3P21
Carolina Power & Light Company

FILE: NG-3514(B)

SERIAL: NO-80-761

BRUNSWICK STEAM ELECTRIC PLANT, UNIT NO. 2
DOCKET NO. 50-324
LICENSE NO. DPR-62
CYCLE 4 RELOAD ANALYSIS AND EOC-RPT
DOCUMENTATION OF VERBAL RESPONSES

FIGURE 14

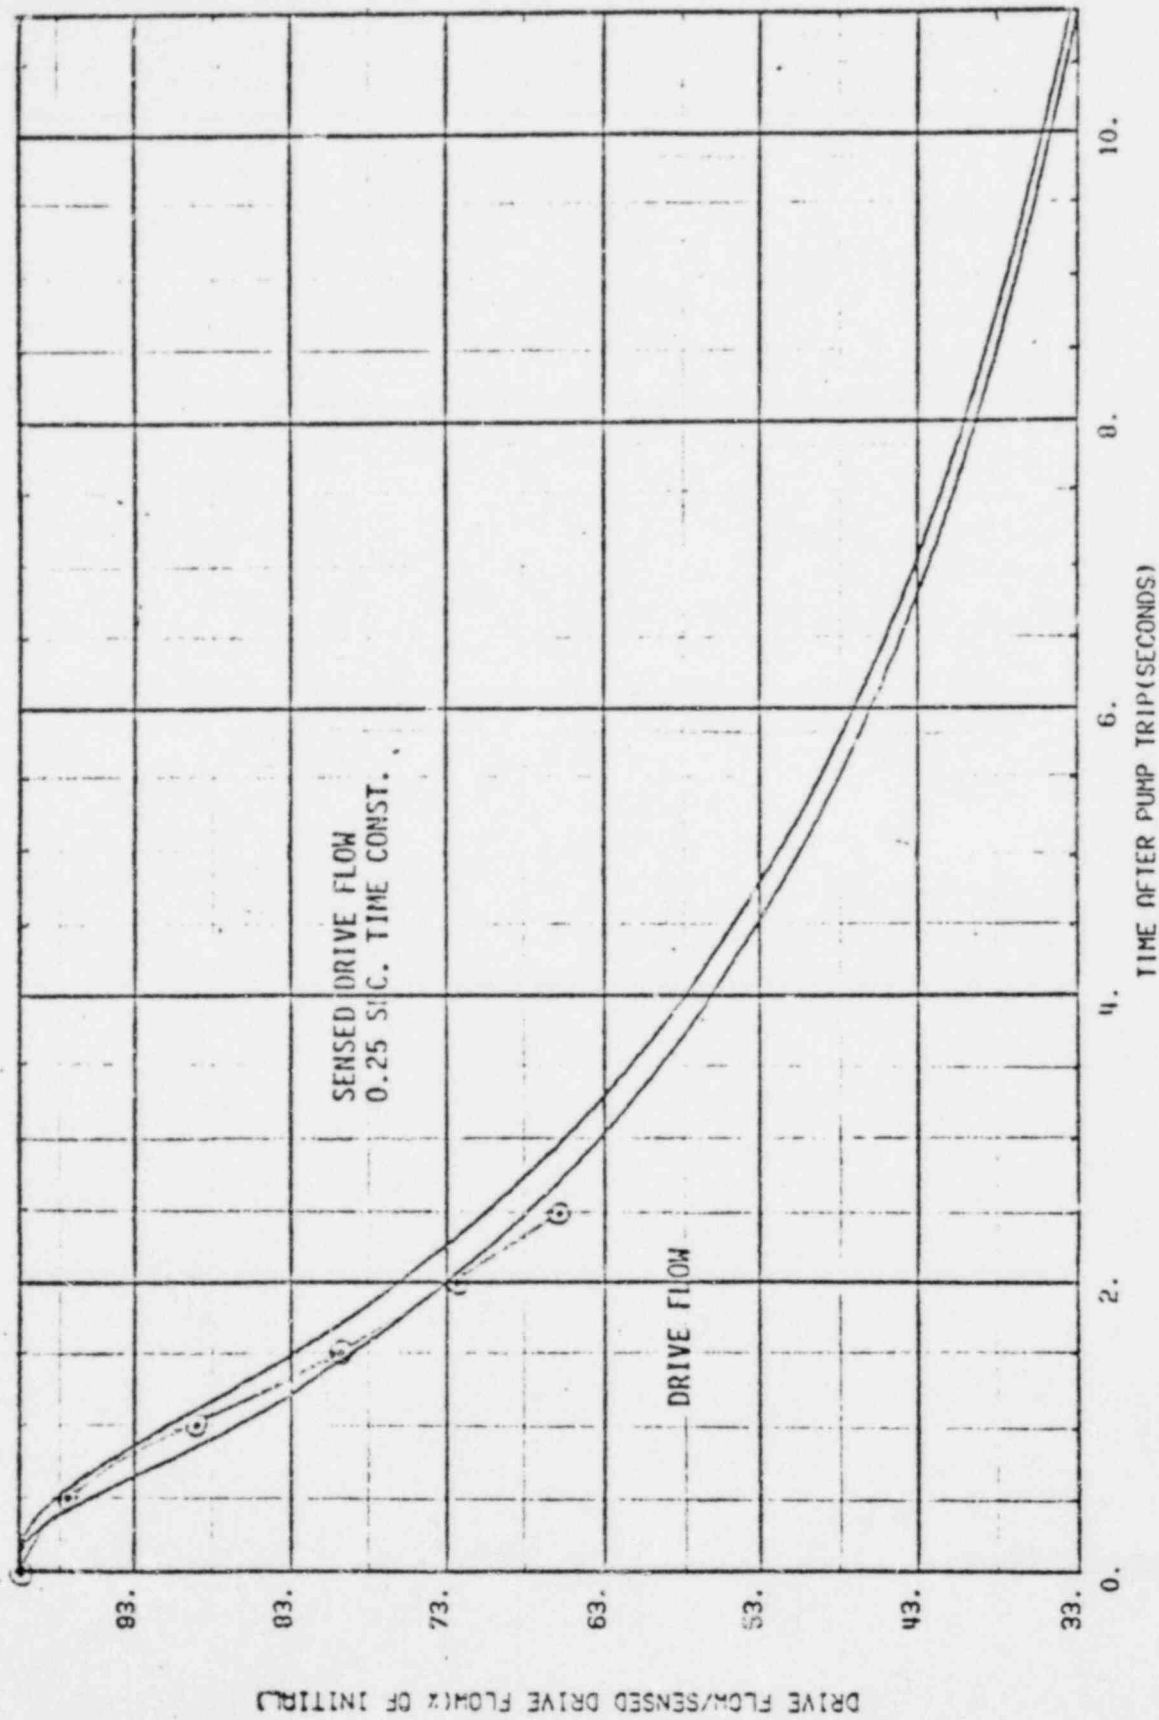
Brunswick Unit 2 tested its EOC-RPT system as it was shutting down for refueling at the end of Cycle 3. The test was performed at 73% power and 97% core flow. The criteria to be met was for the EOC-RPT breaker response time to be less than or equal to 175 msec. and the recirculation pump flow coastdown curve was to fall within the coastdown curve predicted by General Electric (GE) for the BSEP-2 system. The indicated response time (175 msec.) was that assumed by GE in their EOC-RPT analysis. Refer to Attachment 1 for an outline of this assumption. The predicted flow coastdown curve was based on Brunswick-specific input data and the calculation of an inertial constant calculated from the pump/motor nameplate data, to which a 15% design factor for conservatism has been added. The measured response time was 105 msec., and, as can be seen from Attachment 2, the measured coastdown curve falls within the bounds of the predicted curve. A summary of the parameters measured for this test is presented in Attachment 3. The 105 msec. response was determined from two components: (1) 20 msec. from initial turbine stop valve movement to the 90% open position switch actuation, and (2) 85 msec. from the 90% open position switch actuation to load current arc suppression.

The predicted coastdown curve is conservative for Cycle 4 and future cycles because the curve was calculated with an additional 15% inertia included in the pump/motor inertia calculation which tends to increase the coastdown time. Since there is no known mechanism which would increase the pump/motor inertia, this predicted curve will be conservative.

Since the EOC-RPT system was tested, a modification was installed on the recirculation pumps which required an increase in diameter of the pump shaft and associated parts. This change increased the pump/motor inertia by only 9.0 lb-ft². GE has evaluated this change, which was less than 0.1%, and has determined it to be insignificant with regard to the predicted coastdown curve.
